Report of Geotechnical Investigation  
Dam Safety Assessment of Coal Combustion  
Surface Impoundments  
Kentucky Utilities, a Subsidiary of E.ON U.S.  
Tyrone Generating Station, Tyrone, KY

AMEC Project No. 3-2106-0177.0004

September 2010

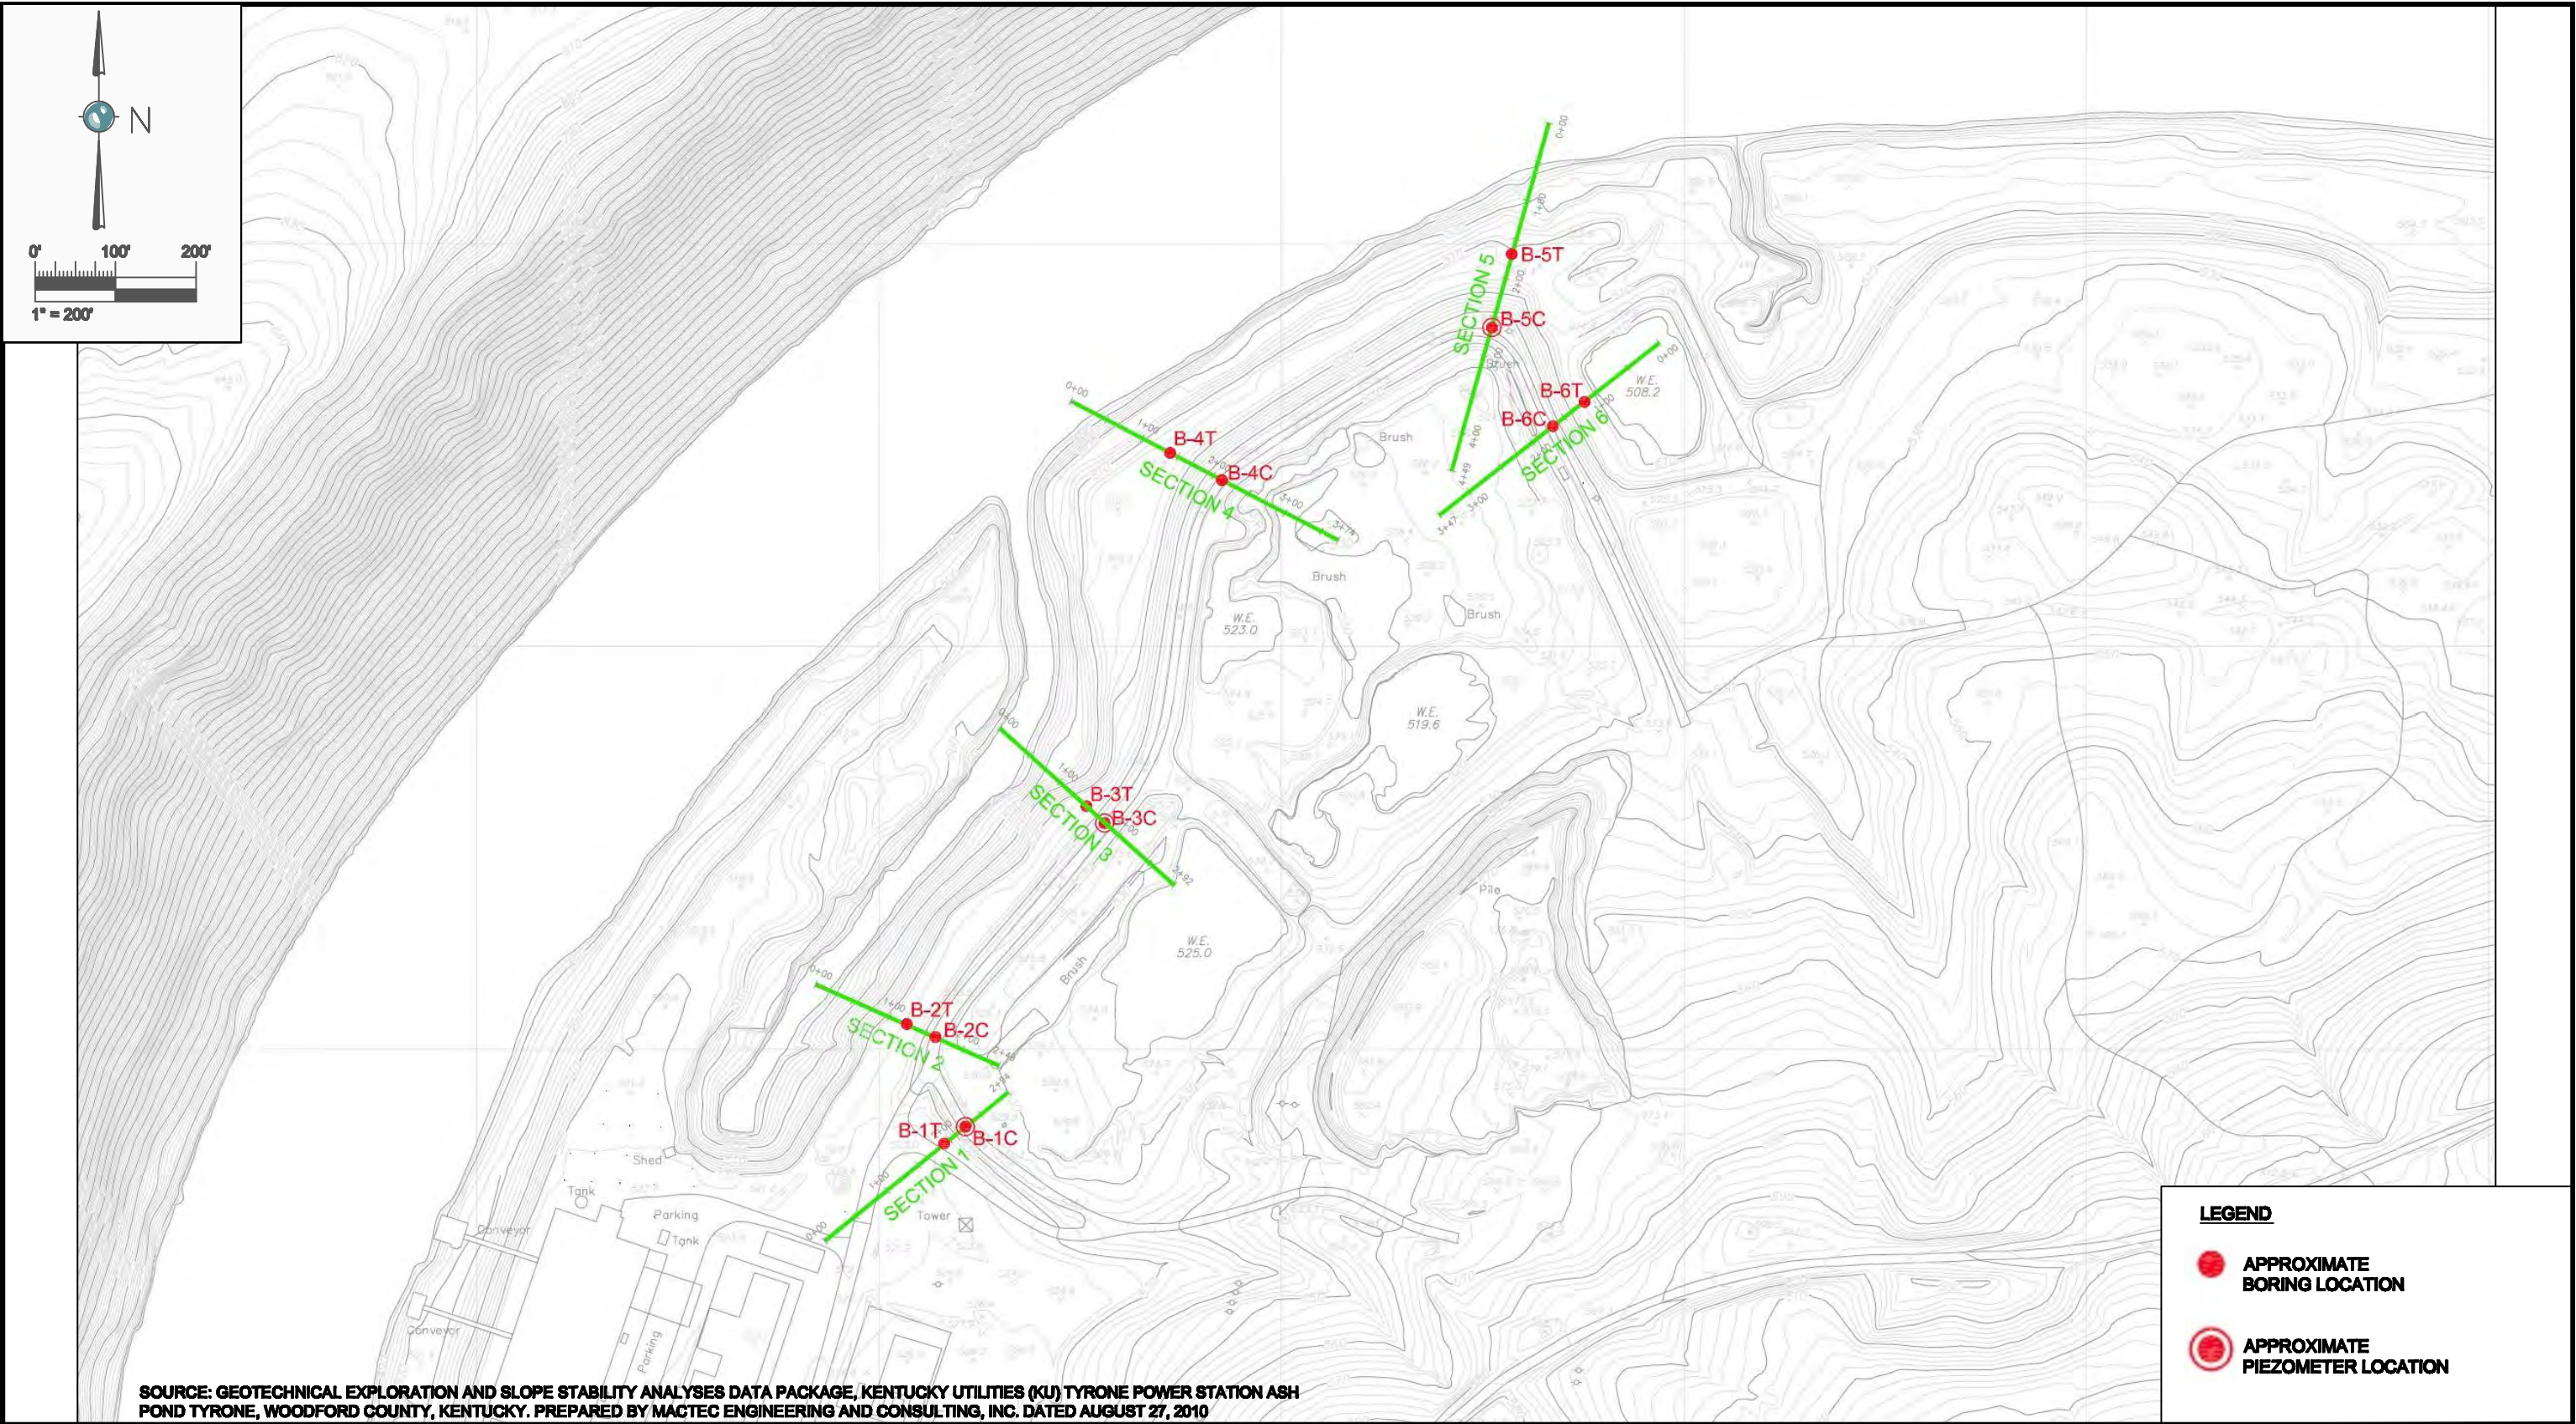
The provided stability analysis by MACTEC dated August 27, 2010 analyzed two cross-sections, one on the northwest corner and one on the north dike. The stability analyses were performed using the existing over-steepened slopes, existing loading conditions, and a seismic acceleration. The minimum safety factors are generally in line with the recommended criteria as stated above. The results generally indicate safety factors well above the minimum target values. However, in the opinion of the assessing professional engineer, the analyses should be revised in accordance with the following recommendations. The analysis should consider all critical stages over the life of the pond including pond full conditions. These conditions would need to be determined in conjunction with the hydrologic and hydraulic recommendations above. The hydrologic and hydraulic analysis will provide a phreatic surface through the embankment. The almost vertical phreatic surfaces shown in the analysis are not typical.

Some of the analyses presented appear limited to a circular surface; different types of failure surfaces should be analyzed and optimized. We understand additional laboratory results and analyses of other sections are to be performed as part of this study. Considerations at other sections include elevated water levels and soft foundation soils encountered at Section 1 and steep natural slope conditions below the sections on the west dike. The study should be revised to address the recommendations in this report and reviewed when complete. The completed analyses should include data sheets to show all input parameters, discussion on how each parameter was derived and preferably an AutoCAD (or equivalent) section to facilitate review.
